FERGUSON TOWNSHIP PLANNING COMMISSION REGULAR MEETING AGENDA

SUBJECT: West College Avenue Student Housing Final Land Development Plan

SUBJECT: West College Student Housing Final Land Development Plan Review 2nd Review.

SUBJECT: Aspen West College Student Housing Final Land Development Plan
Second Review (ES – 409)

BUILDING SIGN DETAIL
NOT TO SCALE

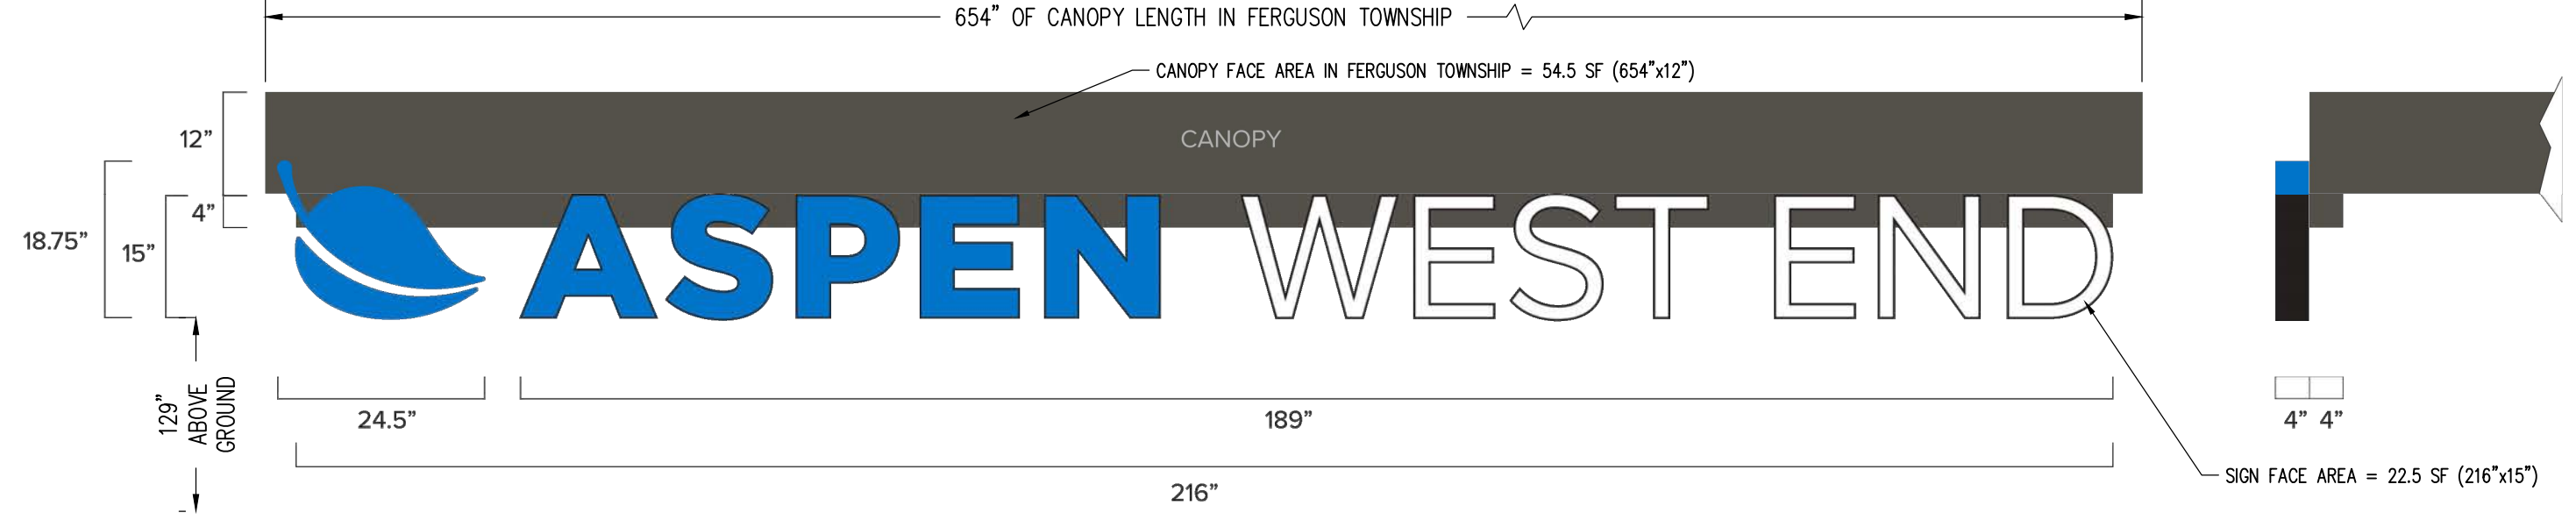
-
1. The face area of signs as regulated by the Signs Regulations must be included on the plan. [Chapter 19, Part 1] (Chapter 22, Section 401.1.A.1.m) The sign size must be adjusted. **Comment Not Addressed.**
